Re: **Jefferson Townhomes**  
**99999 Jefferson St. SE**  
**Traffic Circulation Layout**  
Engineer's Stamp 09-21-22 (K17-D099A)

Based upon the information provided in your submittal received 09-28-22, the above referenced plan cannot be approved for Building Permit until the following comments are addressed:

SITE PLAN & TCL

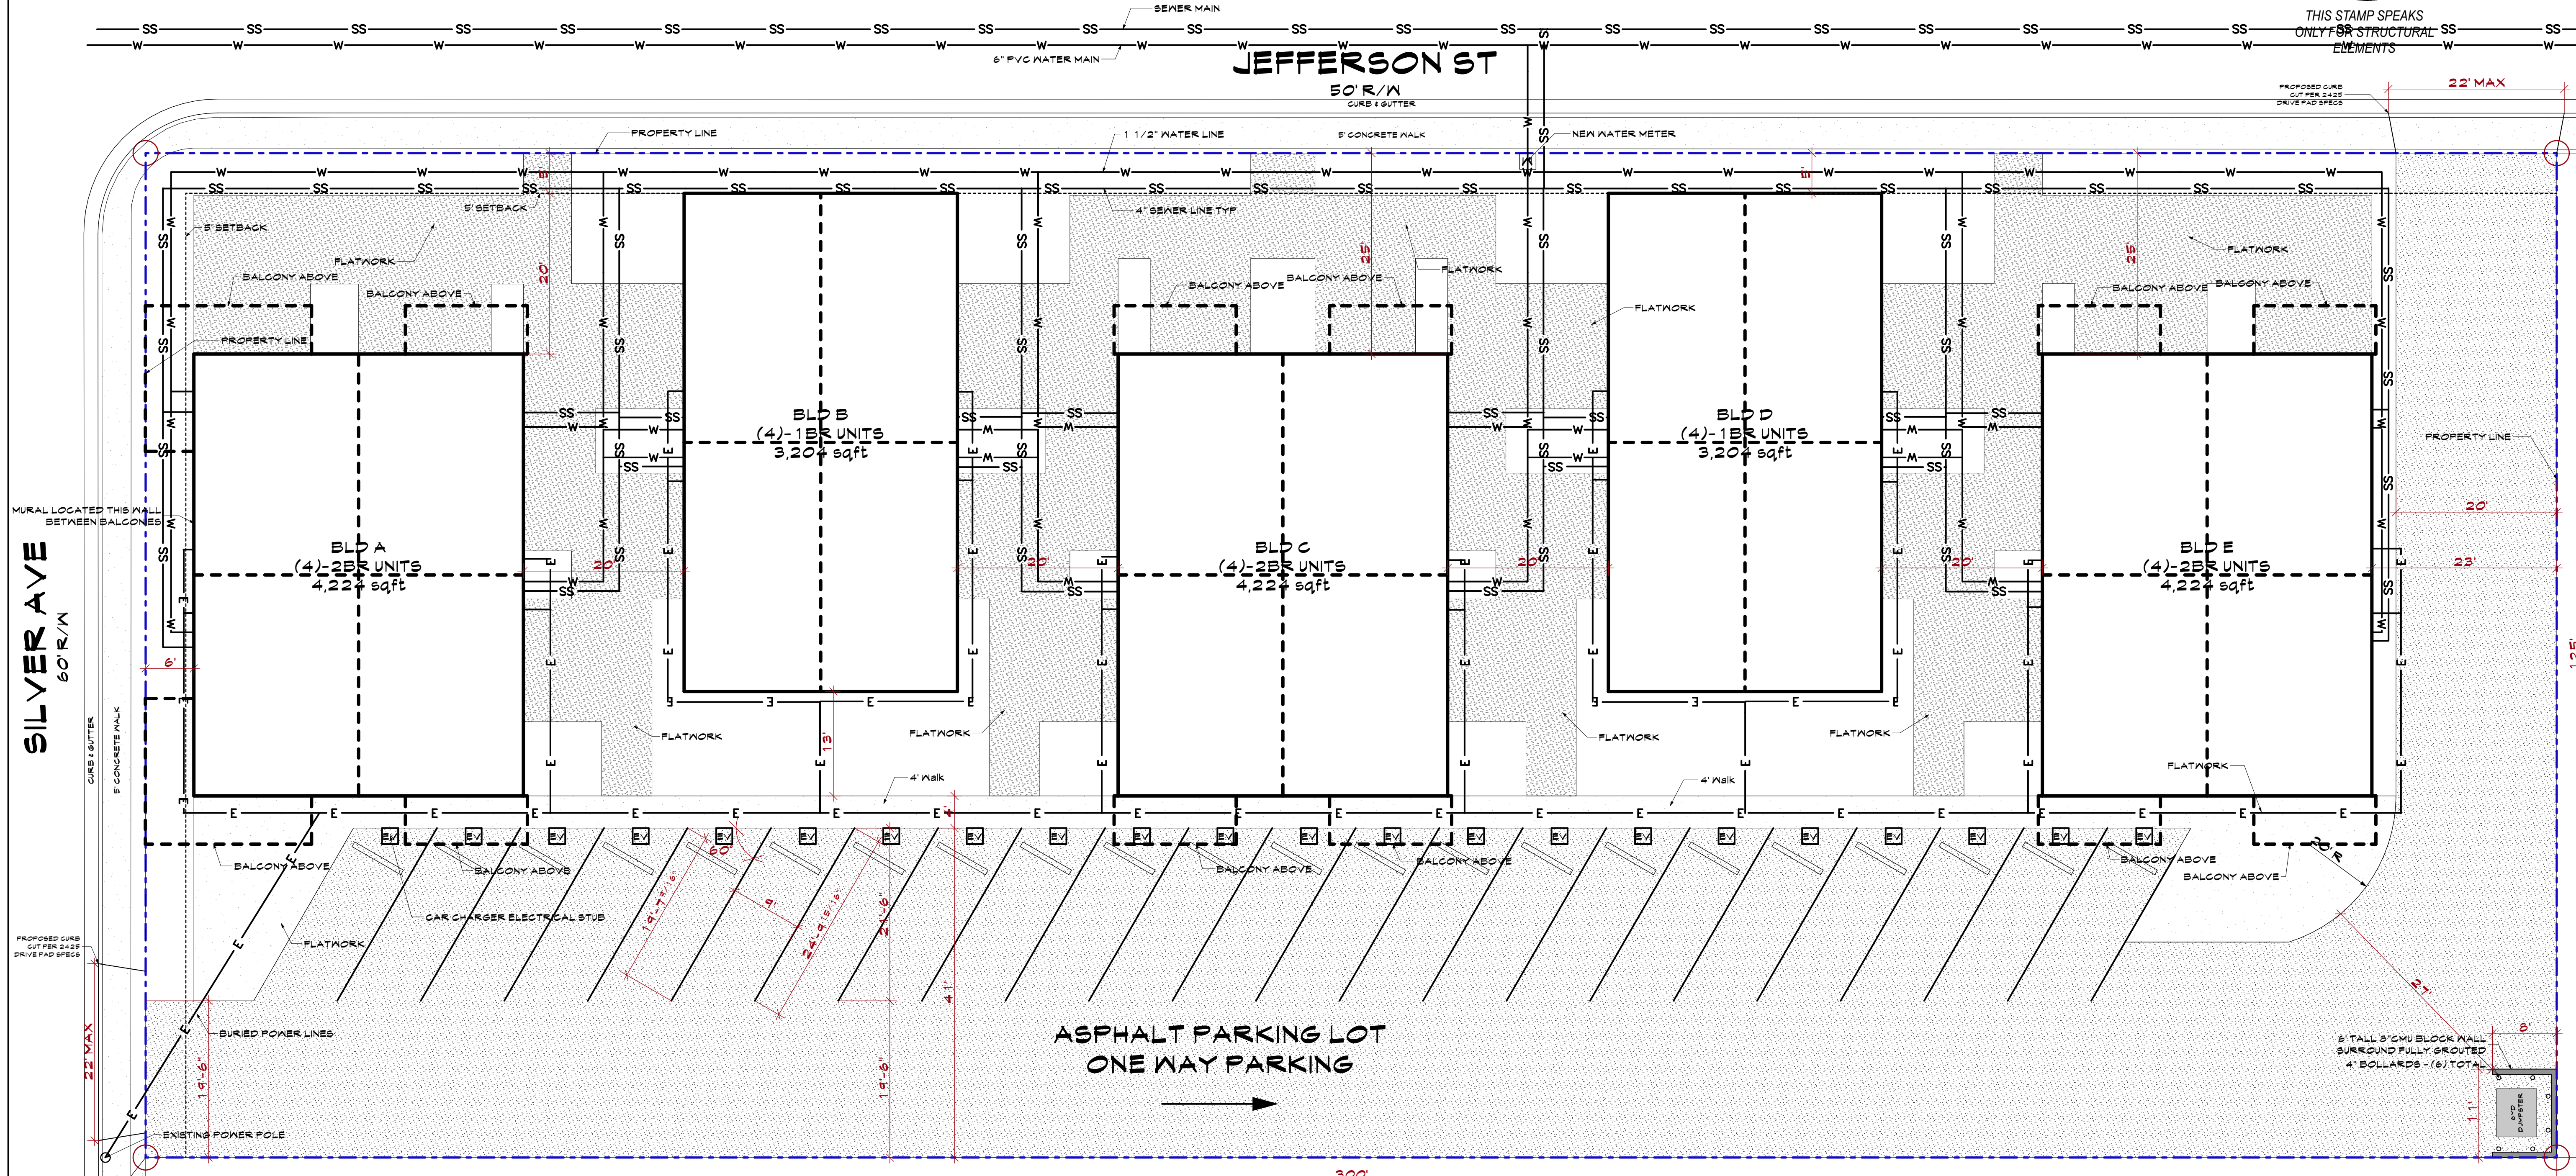
1. List the number of Motorcycle and Bicycle parking spaces required by the IDO.
2. ADA parking spaces need to be provided. See attached Accessible Parking requirements.

3. The width for the 60 degree angled parking should be min. 9.8 ft.
4. The ADA accessible parking sign must have the required language per 66-7-352.4C NMSA 1978 **"Violators Are Subject to a Fine and/or Towing."** Please call out detail and location of signs.

5. The ADA access aisles shall have the words **"NO PARKING"** in capital letters, each of which shall be at least one foot high and at least two inches wide, placed at the rear of the parking space so as to be close to where an adjacent vehicle's rear tire would be placed. (66-1-4.1.B NMSA 1978)

6. ADA curb ramp at the corner of Jefferson and Silver Ave. SE, must be updated to current standards and have truncated domes installed.
7. Motorcycle parking spaces shall be designated by its own conspicuously posted upright sign, either free-standing or wall mounted per the zoning code.

8. The pavement marking "MC" should be shown in the opposite direction for motorcycles entering the parking space.
9. All bicycle racks shall be designed according to the following guidelines:

- a. The rack shall be a minimum 30 inches tall and 18 inches wide.
  - b. The bicycle frame shall be supported horizontally at two or more places. Comb/toaster racks are not allowed.

- c. The rack shall be designed to support the bicycle in an upright position. See the IDO for additional information.
  - d. The rack allows varying bicycle frame sizes and styles to be attached.

- e. The user is not required to lift the bicycle onto the bicycle rack.
- f. Each bicycle parking space is accessible without moving another bicycle.
- 10. Bicycle racks shall be sturdy and anchored to a concrete pad.

- 11. A 1-foot clear zone around the bicycle parking stall shall be provided.
- 12. Bicycle parking spaces shall be at least 6 feet long and 2 feet wide.

- 13. Per the IDO, a 6 ft. wide ADA accessible pedestrian pathway is required from the public sidewalk to the building entrances. Please clearly show this pathway and provide details.

- 14. Per DPM, a 6 ft. wide ADA accessible pedestrian pathway is required from the ADA parking stall access aisles to the building entrances. Please clearly show this pathway and provide details.

- 15. ADA accessible pedestrian pathway should not be placed behind parking space or adjacent to a vehicular way. Vehicle and pedestrian/wheel chair conflicts should be avoided as much as possible.

- 16. Define ADA pathways by labeling of ramps, flush pavement, dimensioning of pathways, doorways, etc.
- 17. Refuse vehicle maneuvering shall be contained on-site. The refuse vehicle shall not back into the public right of way.; provide a copy of refuse approval.

- 18. Please provide a copy of Fire Marshal approval.
- 19. All one-way drives shall have "One Way" and "Do Not Enter" signage and pavement markings. Please show detail and location of posted signs and striping.

- 20. Show the clear sight triangle and add the following note to the plan: "Landscaping and signage will not interfere with clear sight requirements. Therefore, signs, walls, trees, and shrubbery between 3 and 8 feet tall (as measured from the gutter pan) will not be acceptable in the clear sight triangle.

- 21. Please specify the City Standard Drawing Number when applicable.
- 22. Unused curb cuts must be replaced with sidewalk and curb & gutter. A build note must be provided referring to the appropriate City Standard drawing.
